DA 2024/489

33 CROSS STREET DOUBLE BAY

RESPONSE TO SUMMARY OF REFERRAL RESPONSE – INDEPENDENT URBAN DESIGN

Figure 7: Window and planter design supporting landscape maintenance

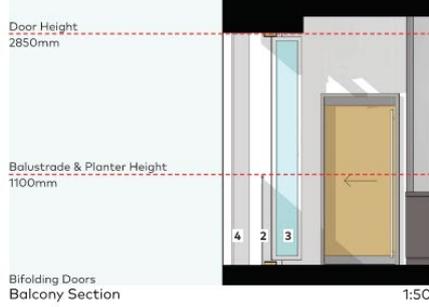
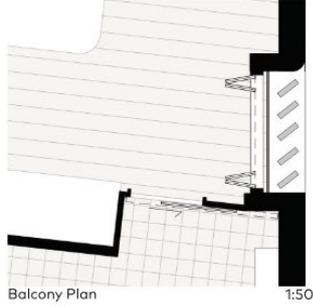
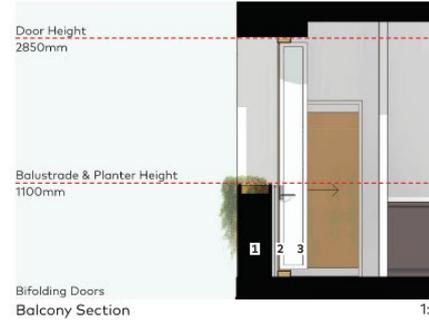
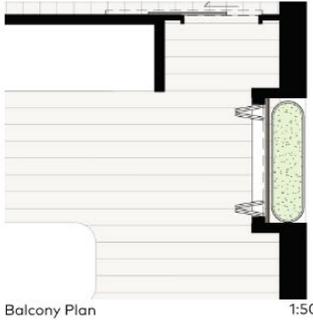
'However, many of the landscape planter boxes located in the side elevations are impractical and will be difficult to maintain.'

The windows on the western and eastern boundaries have been amended to open inwards with balustrades, allowing for safe access and maintenance of the planters from within the units. This ensures compliance with safety standards while maintaining the visual and environmental benefits of integrated greenery. Additionally, the windows have been inset and the planter has been increased on the eastern boundary for additional visual privacy.

Figure 10: Proposed retail strip located under awning on ground floor

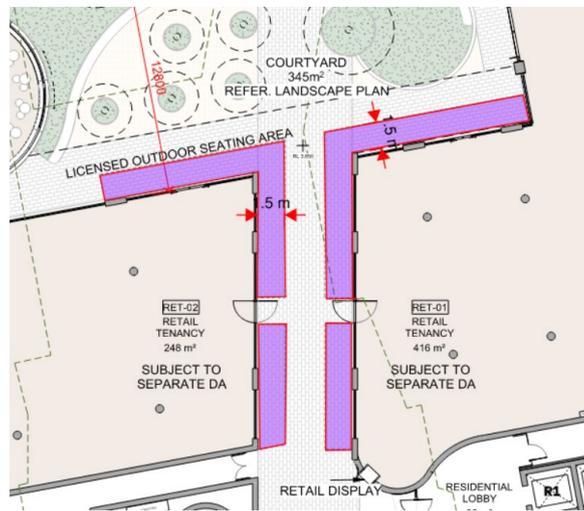
- The **roof design** appears unresolved, with no visible indication of plant or lift overruns.
- The proposed **licensed outdoor courtyard** raises potential concerns regarding **acoustic amenity and privacy** impacts on nearby residential properties.

The development application does not seek approval for the use of the retail tenancies or licensing, as these will be subject to future separate applications. The landscaped courtyard area is not designated as licensed, and there is no outdoor licensing proposed in the courtyard.

The development includes a small outdoor retail strip under the acoustic treated awning, located approximately 1.5m from the retail facades, as shown on the Drawing A-DA-2110 (shown below). A management plan will be developed in consultation with future development applications for the use of the retail tenancies and Council to ensure ongoing safety and amenity.

Figure 15: Overshadowing diagram of the proposed development prepared by COX

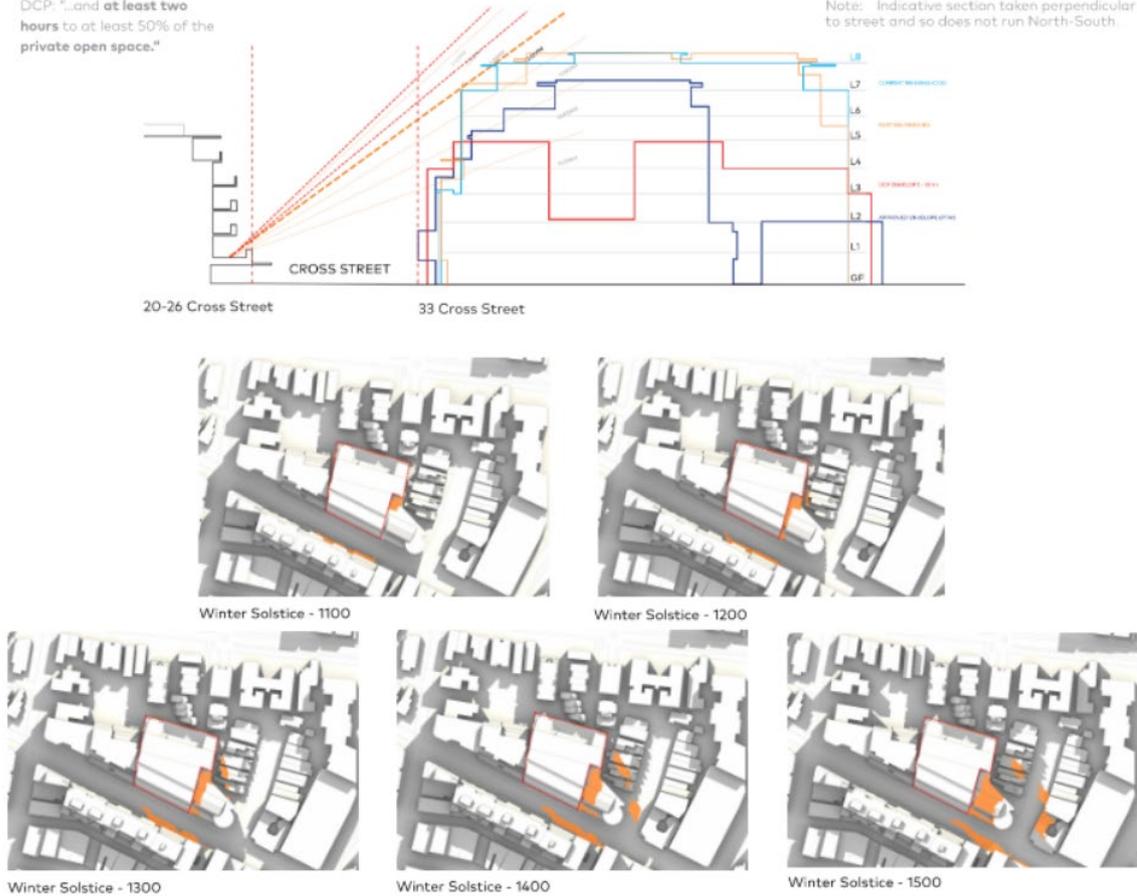
- The development **does not propose any dedicated communal open space**.
- **Overshadowing of the southern footpath** on Cross Street is anticipated during midwinter, particularly between 11:00 am and 3:00 pm.

- North-facing windows and private open spaces of nearby residential buildings will continue to receive the minimum required three hours of direct sunlight to windows and two hours to private open space, in full compliance with the Double Bay Development Control Plan (DCP).

- Mature street trees along the footpath currently provide significant shade, meaning much of the area is already partially obstructed from direct sunlight. Furthermore, no outdoor seating or recreational infrastructure is located along this portion of footpath.

Accordingly, in our opinion, the proposal complies with Council's DCP controls through maintaining adequate solar access to nearby development, and ensuring the extent of additional overshadowing on the public domain and footpath on the southern side of Cross Street is minimised. The proposal also complies with the ADG requirements for solar access to the proposed residential units.

Figure 24: Design improvements on western and eastern boundary to improve visual privacy, prepared by COX

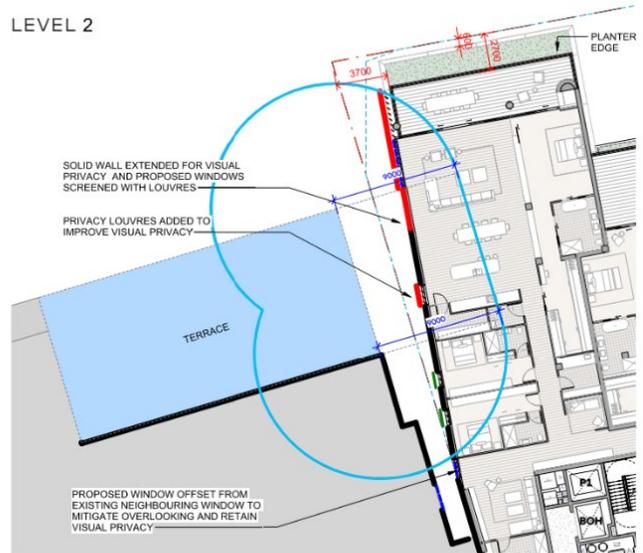
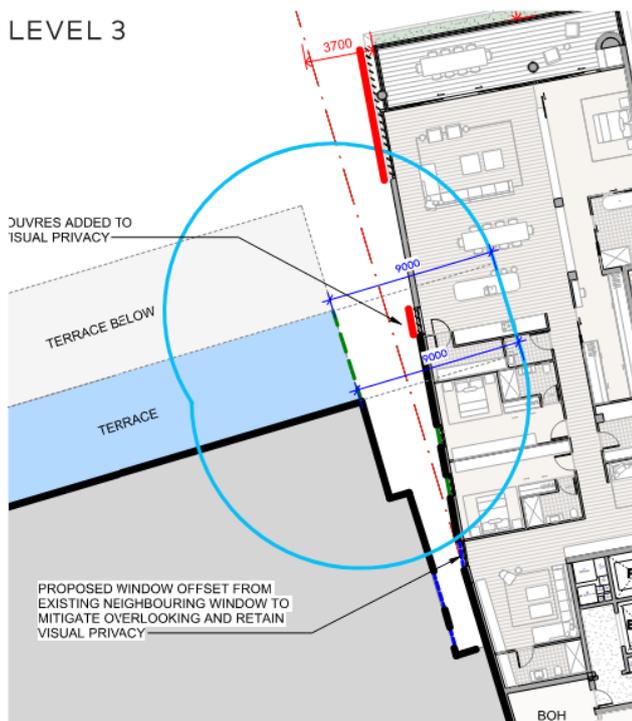
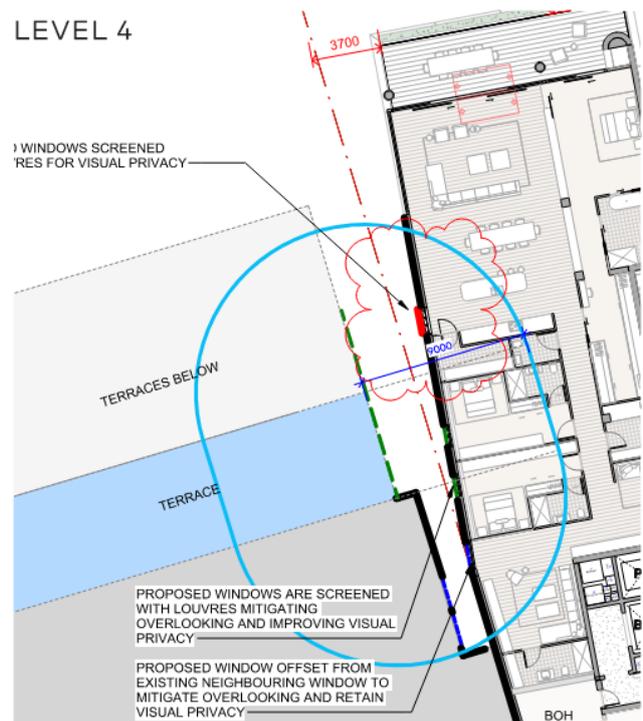
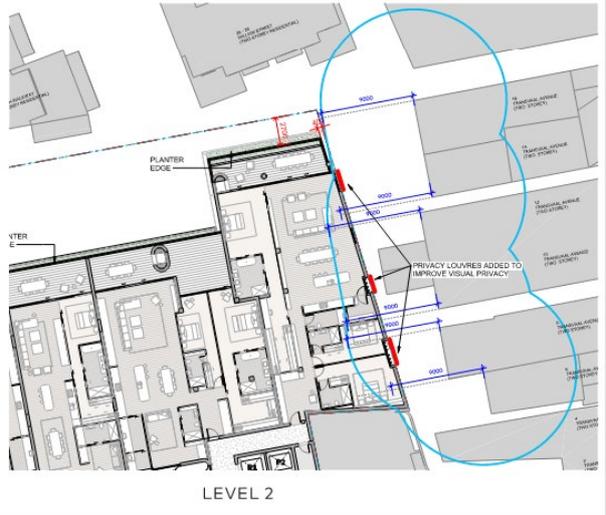
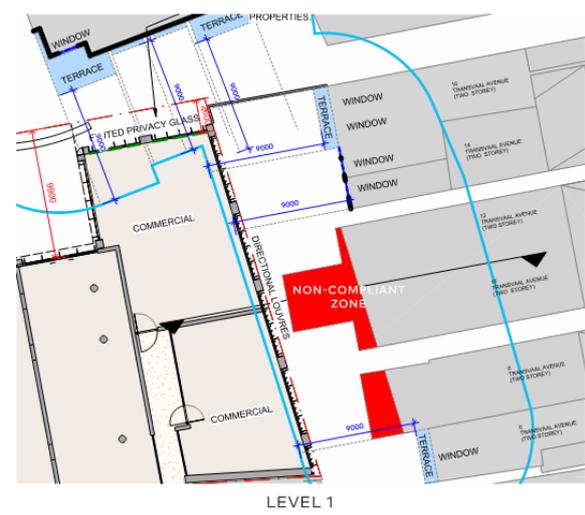
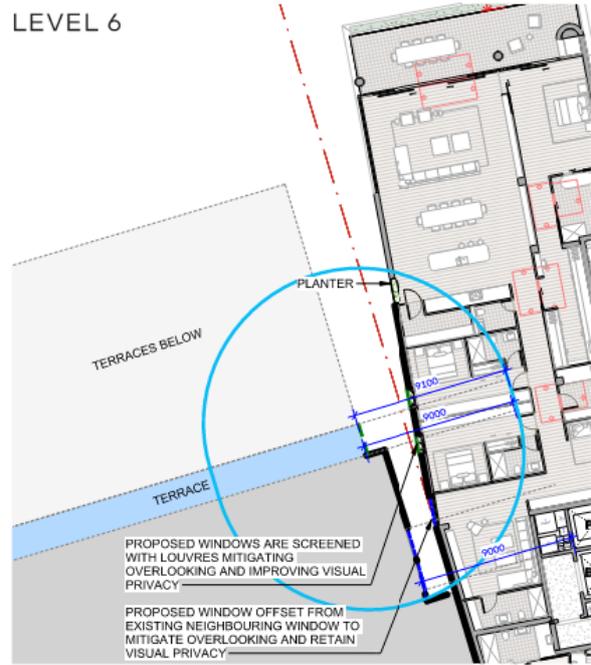
- **Level 2 planters** re-positioned by **600mm**, and **solid balustrades** introduced to improve **visual privacy** for neighbouring properties (*Section 3F – Visual Privacy*).

- A **solid wall extension** on the western boundary and the addition of **privacy louvres** to the eastern and western elevations further enhance privacy (*Section 3F – Visual Privacy*).

- Extension of the solid wall for improved visual privacy.
- Proposed windows will be screened with louvres.
- Blades will be added to the windows on the western and eastern facades to minimise overlooking.

- The planter on level 2 is extended by 600mm from the existing structure to further mitigate overlooking and improve privacy.

Figure 25: Design improvements on eastern boundary to improve visual privacy, prepared by COX

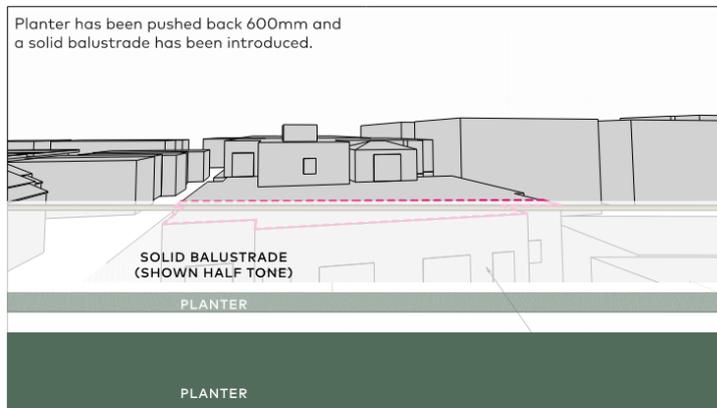
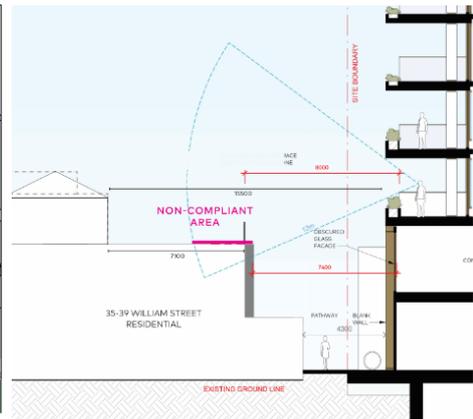
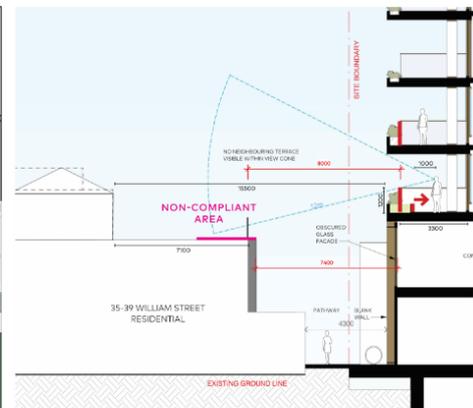
- **Inset the windows** on the eastern elevation and increased the planter for additional visual privacy.

Figure 31: Proposed retail strip located under awning on ground floor

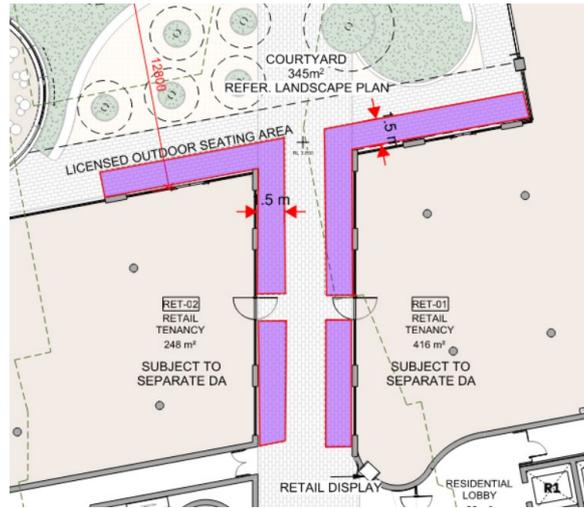
'However, the north elevation drawing indicates the wall height to be 3.8 metres (approx.). I find it difficult to accept that an outdoor licensed seating area of 345 sqm proposed to be open until 10.00pm that is 2.7 metres from an existing two storey townhouse will have no acoustic impact. The basement car park is offsite.'

The development has been carefully designed to mitigate acoustic impacts, avoid unreasonable amenity loss, and ensure compliance with Council policy and environmental standards. There is no proposed licensing of the courtyard, and outdoor seating is both limited in scope and acoustically managed. In our opinion, the concerns raised are adequately addressed through the design response and supporting expert assessments.

- This courtyard is not designated as a licensed premises, nor is outdoor alcohol service proposed as part of this Development Application.
- The development includes a modest outdoor retail seating zone located directly adjacent to the building line under an acoustically treated awning, as shown in Drawing A-DA-2110.
- The proposed seating is limited in extent and scale, with the acoustic report assessing up to 30 seats in this area. There is no outdoor music or amplified sound proposed.
- From 10:00pm onward, all hospitality and retail operations will be fully enclosed within the internal tenancies, and no external activity will occur after this time.

The Renzo Tonin Acoustic Report, submitted with the application, confirms that this limited external activation is acoustically compliant and will not result in unreasonable noise impact to adjacent residences.
